Access Compliance Report

Public Rights-of-Way

(Curb Ramps)

Intersection ID: 23021	Main Street: OLD_PROVIDENCE_RD	Cross Street: LANDING_VIEW_LN	Location: E
ADA ID: 01F1C01B4CF5	Ramp Type: PerpDiag	Initial Pass/Fail: Fail	Overall Compliance: No
Severity Score: 13.75			
Codes/Mitigation Info/Possible Solution		Field Measurements/Component Compliance

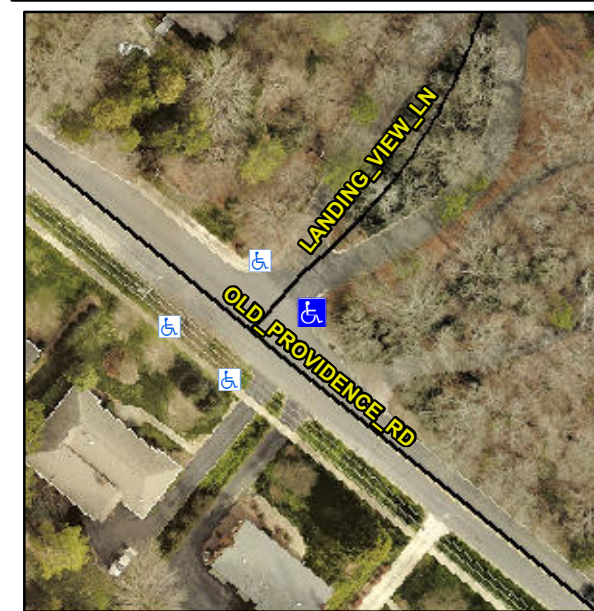
Not Found, R304.2.2, R304.5.3

Compliance	Description	Data	Compliance	Description	Data
N/A	Ramp Length (in)	26.0	No	Ramp Slope (%)	11.7
Yes	Ramp Width (in)	48.0	No	Ramp XSlope (%)	3.8
N/A	Flare Type LT	N/A	N/A	Flare Type RT	N/A
N/A	Flare Slope LT (%)	N/A	N/A	Flare Slope RT (%)	N/A
N/A	Flare Traversable LT?	N/A	N/A	Flare Traversable RT?	N/A
N/A	Landing Length (in)	N/A	N/A	DWS Provided?	N/A
N/A	Landing Width (in)	N/A	N/A	DWS Contrast?	N/A
N/A	Landing Slope (%)	N/A	N/A	DWS Length (in)	N/A
N/A	Landing X Slope (%)	N/A	N/A	DWS Full Width?	N/A
N/A	Landing Curb? (Y/N)	N/A	N/A	DWS Offset (in)	N/A
N/A	Shared Landing?	N/A			
N/A	Gutter Ponding?	N/A	N/A	Gutter Slope (%)	N/A
N/A	Gutter Lip Ht (in)	N/A	N/A	Gutter X Slope (%)	N/A
N/A	Painted X Walk1?	No	N/A	Painted X Walk2?	No
	X Walk 1 Direction	To NW		X Walk 2 Direction	To SW
N/A	X Walk 1 Width (in)	N/A	N/A	X Walk 2 Width (in)	N/A
	X Walk 1 Slope (%)	3.1		X Walk 2 Slope (%)	0.0
	X Walk 1 X Slope (%)	5.4		X Walk 2 X Slope (%)	1.1

N/A	Ramp inside XWalk1?	N/A	N/A	Ramp inside XWalk2?	N/A
	Road Slope (%)	3.8	N/A	Clear Space?	N/A
	Road X Slope (%)	2.8	N/A	Clear Space to XWalk (in)	N/A
N/A	Any Obstructions?	N/A	N/A	Storm Grate/Utility Hazard?	N/A
	Obstruction Type			Storm Grate/Utility Type	
		N/A			N/A
			Yes	Surface Condition? (G/P)	Good

Remove & Replace Curb Ramp With Two New Directional Ramps or Equivalent.
